CITY OF DE PERE

ADDENDUM NO. 1
PROJECT 22-11
2022 UTILITY AND STREET CONSTRUCTION WATERVIEW HEIGHTS FIFTH ADDITION

CHANGES TO PROJECT BID DOCUMENTS:

CHANGES TO PLANS:

BID SET
 SHEET NO.
31R

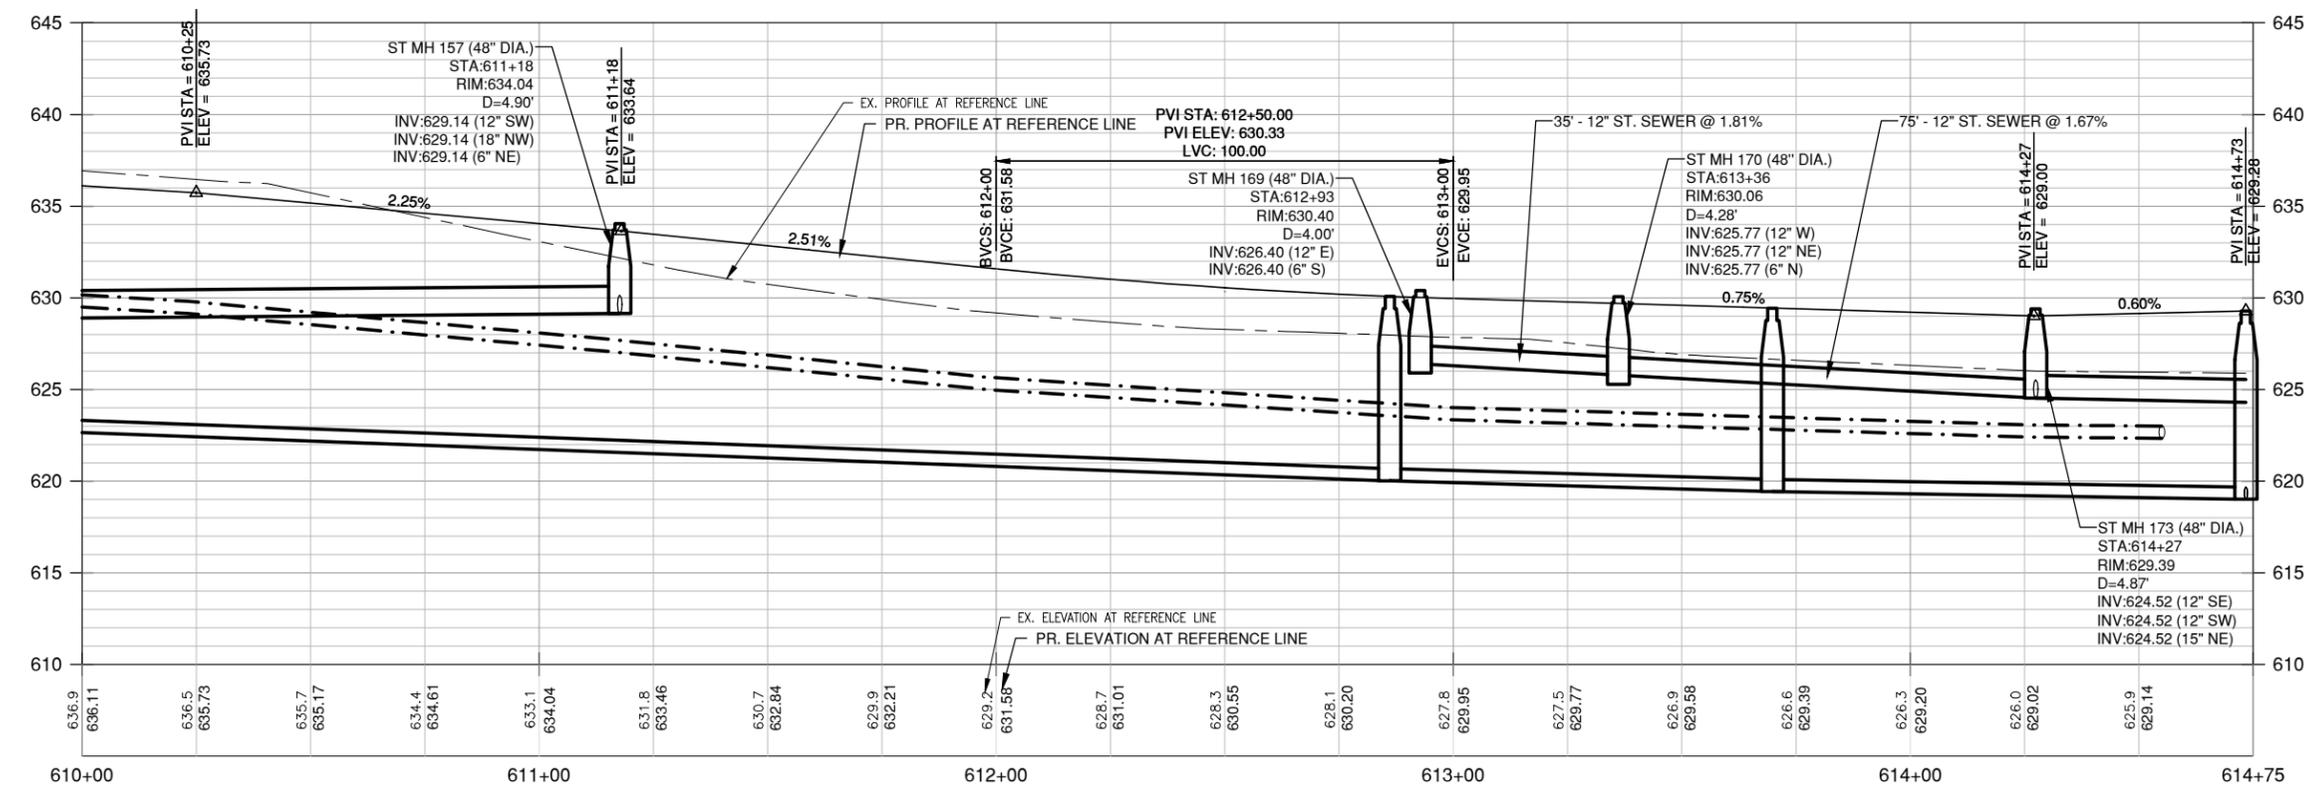
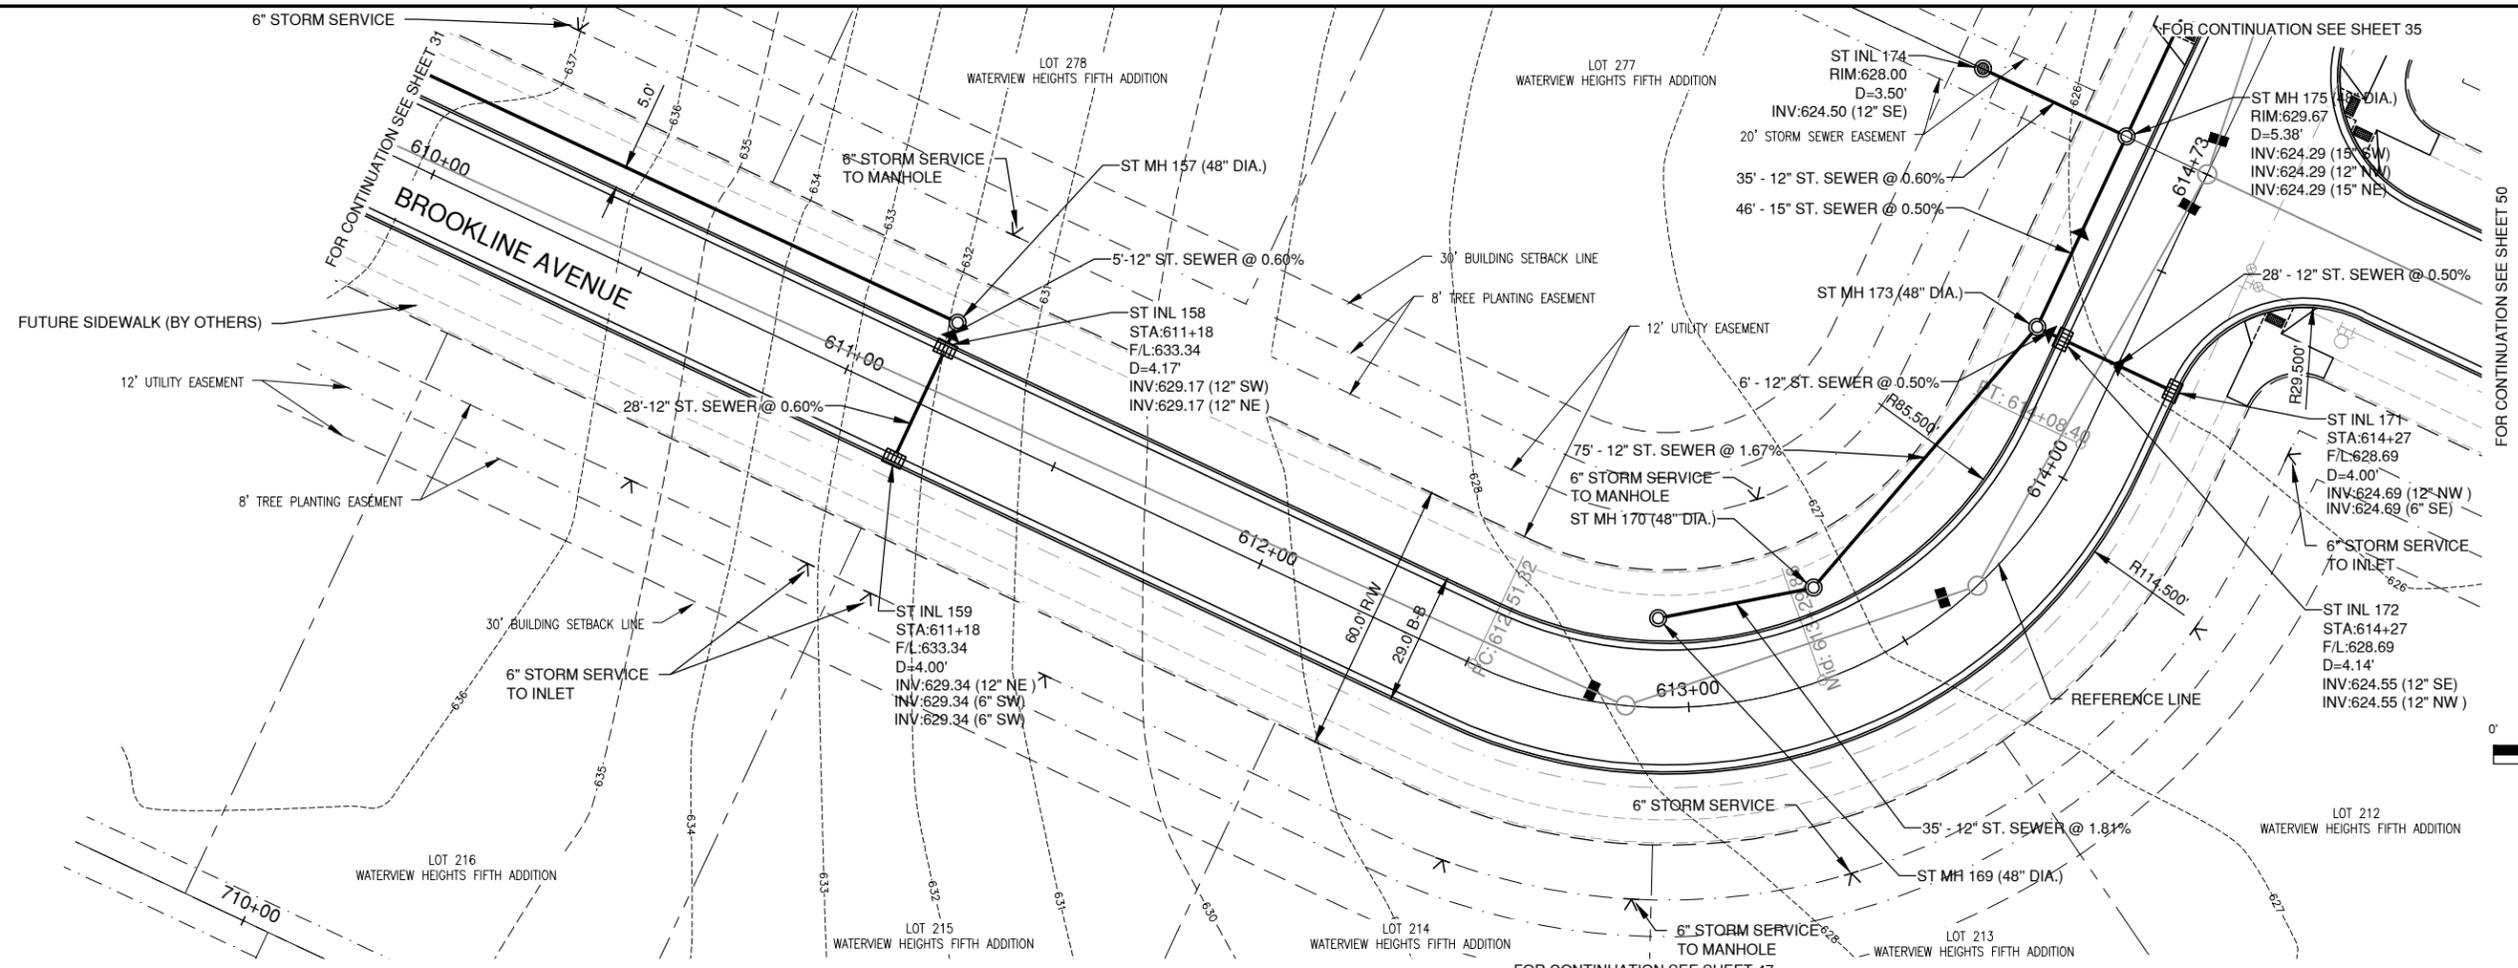
NO.	DATE	APPROV.	REVISION	NO.	DATE	APPROV.	REVISION
1	5/22/2022	BDR	PROFILE DATA SHOWS UP

BID SET
 SHEET NO.
32R

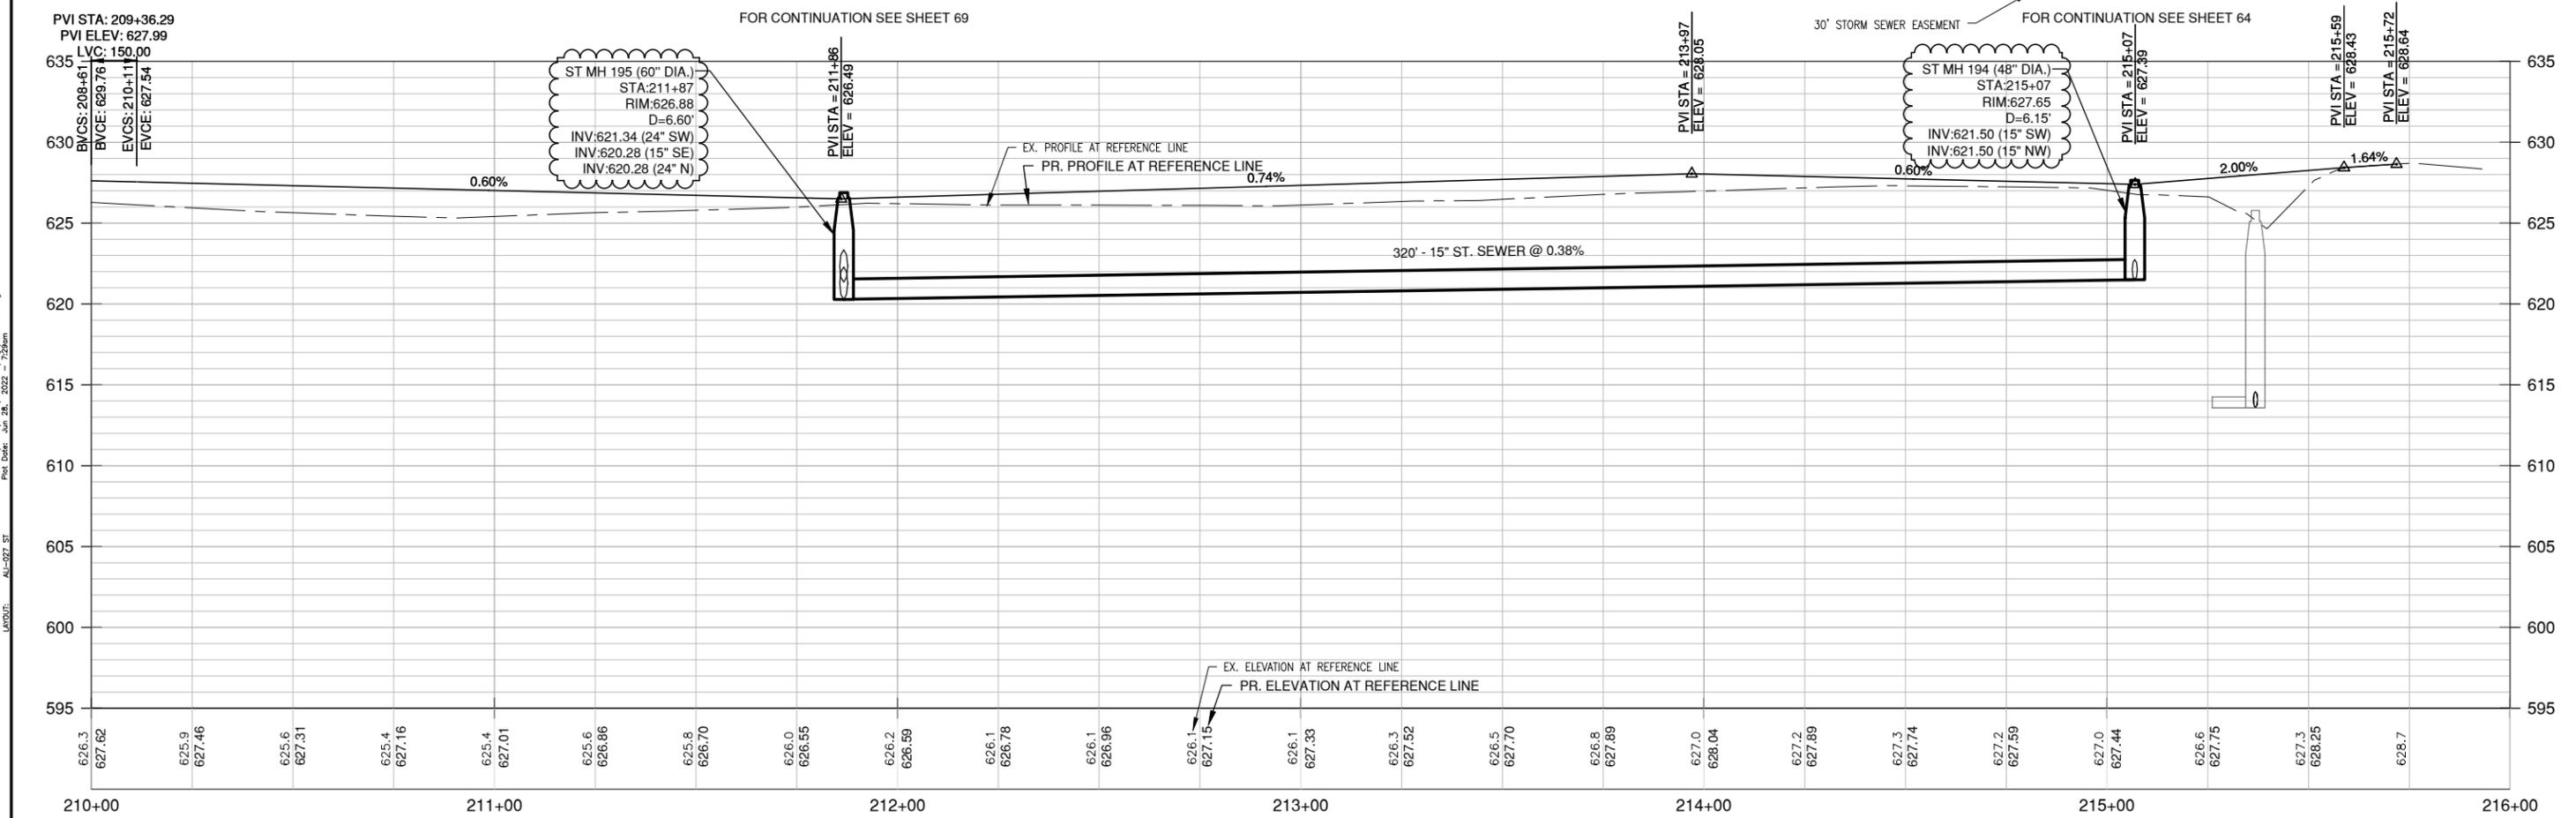
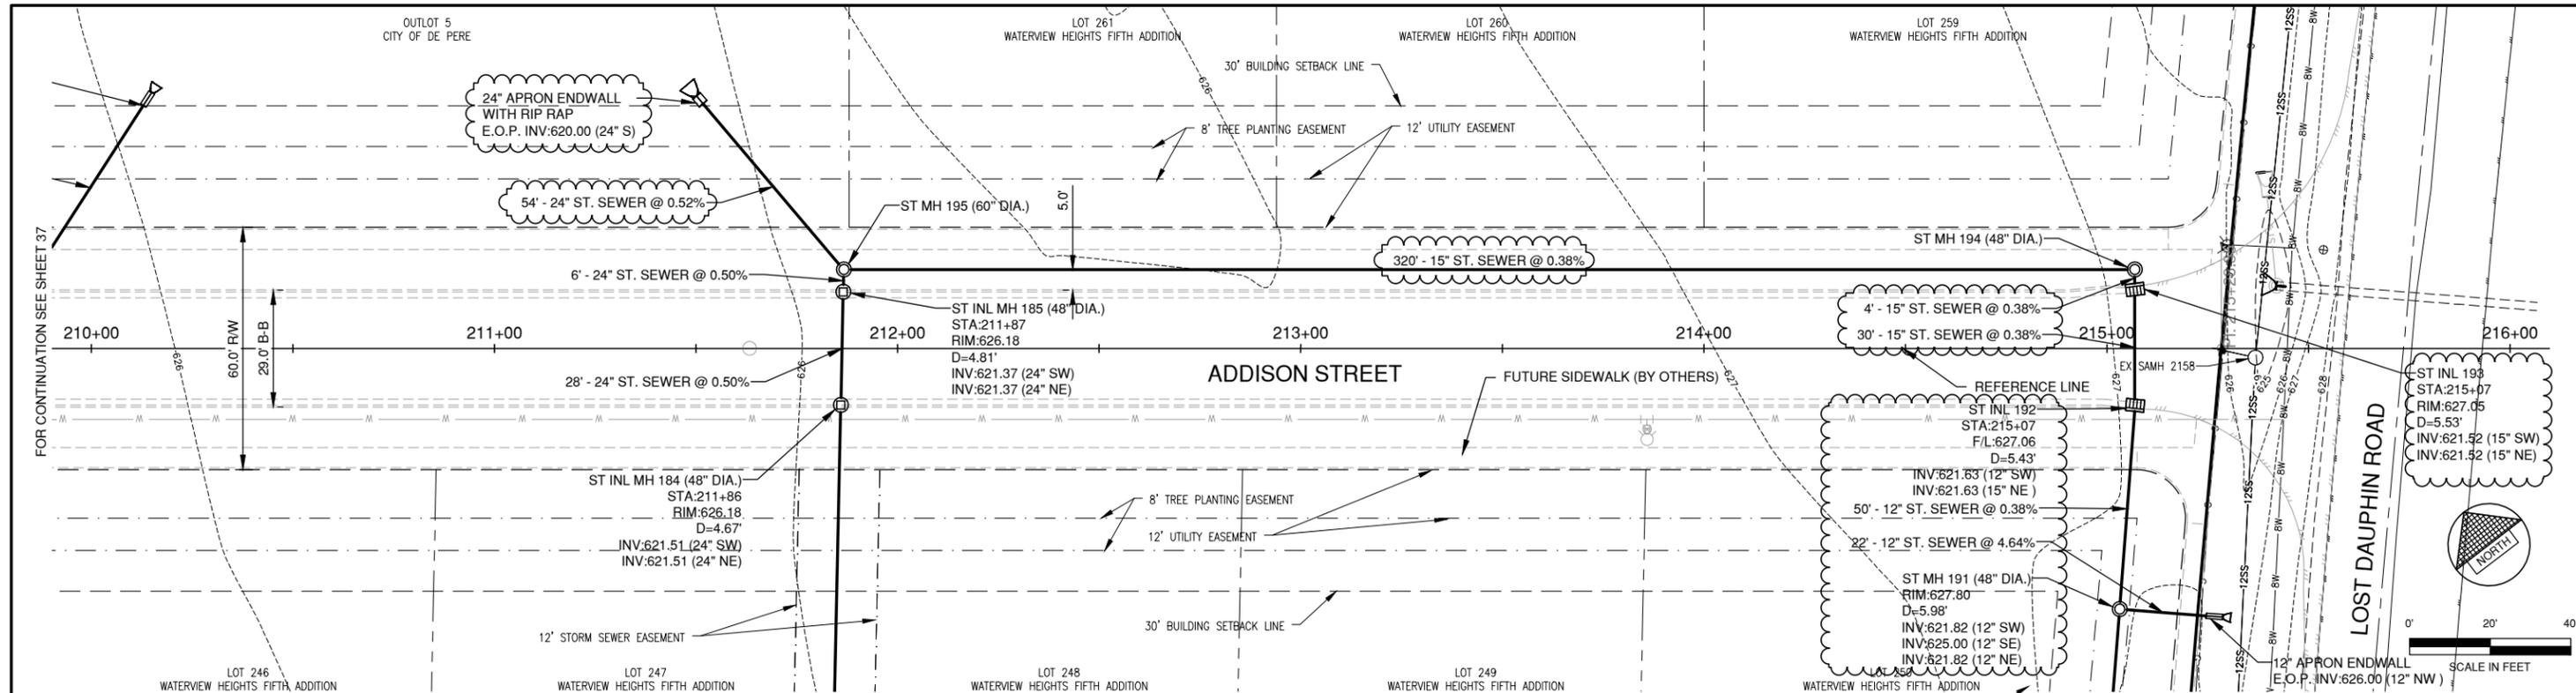
NO.	DATE	APPROV.	REVISION	NO.	DATE	APPROV.	REVISION
1	5/22/2022	BDR	PROFILE DATA SHOWS UP
